**TO:** Tasha Bolivar, Galloway and Company  
**FROM:** Amber Wood Hicken, Planner I  
**DATE:** 2/6/23  
**SUBJECT:** Parker and Pine F1 L1 – In-n-Out Burger, Site Plan  
Review Comments 01

Staff Comments 01  
SP22-143; Parker and Pine  
In-n-Out; Site plan  
2/6/23

IN-N-OUT BURGER  
SITE PLAN  
PARKER & PINE FILING NO. 1, LOT 1

**02 BUILDING MTD. EXTERIOR LIGHTING PHOTOMETRIC PLAN (ZONE #2)**  
SCALE: 1" = 20'-0"

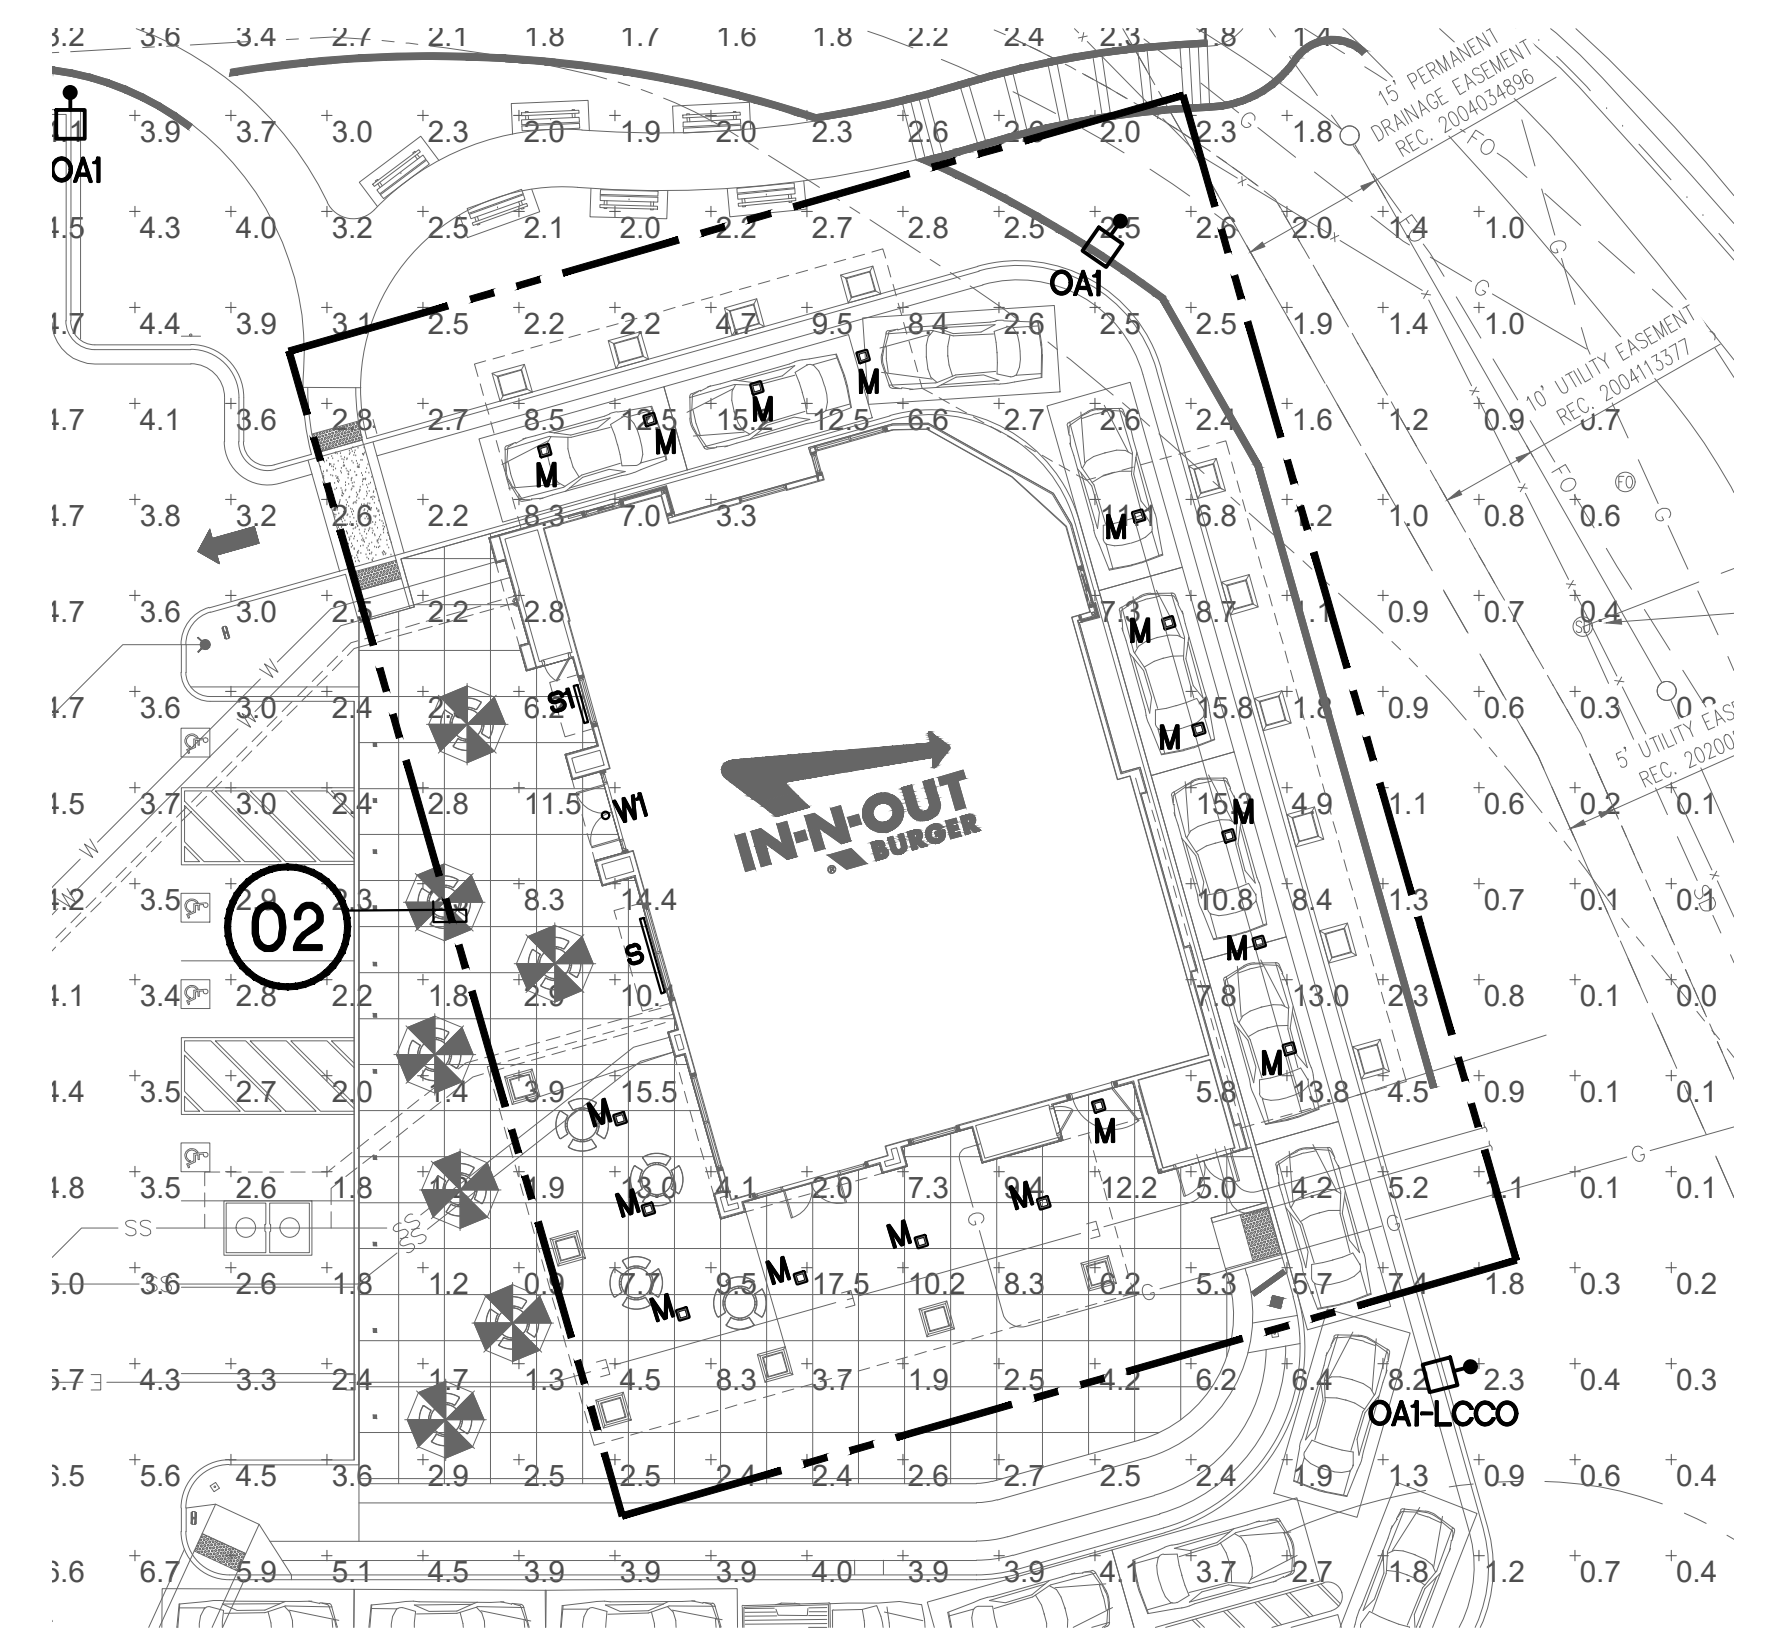
Please add the color of each luminaire.

Max footcandles at lot line is 1.0

**01 SITE LIGHTING PHOTOMETRIC PLAN (ZONE #1)**  
SCALE: 1" = 20'-0"

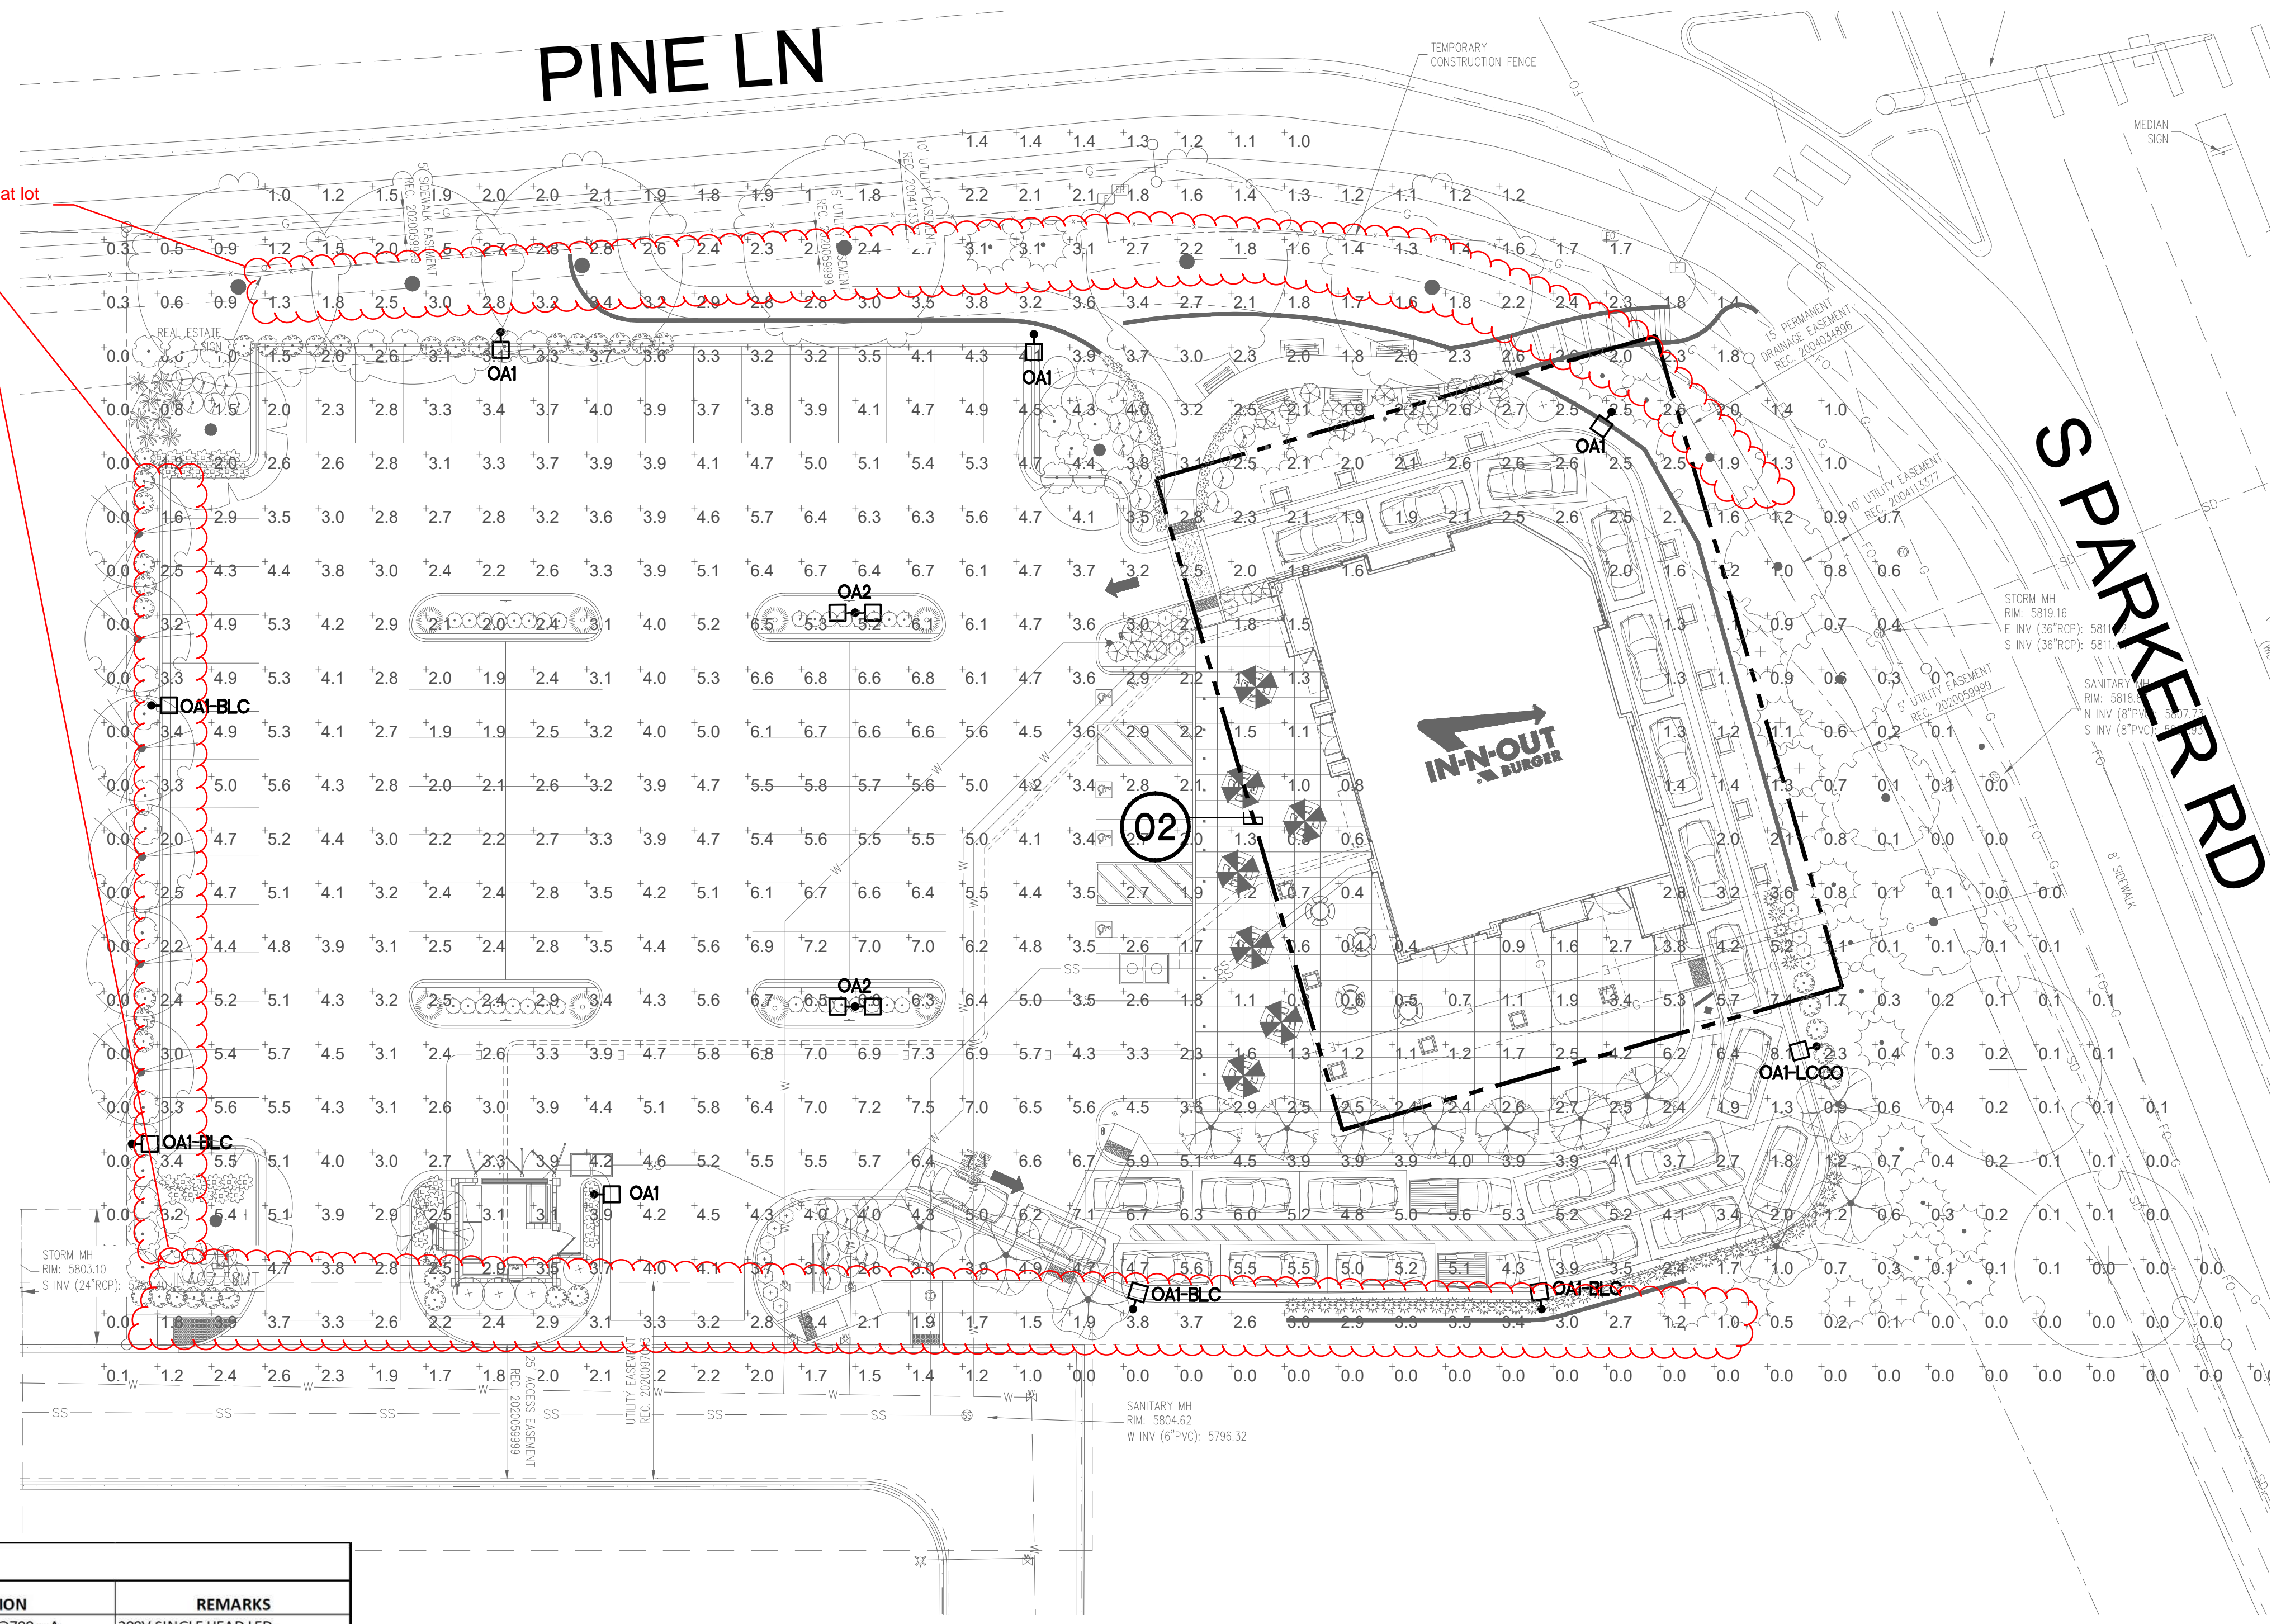
Lumens greater than 15,000 must be shielded

Please label as "parking lot," etc.

Is this number correct? Max footcandles allowed on site is 12
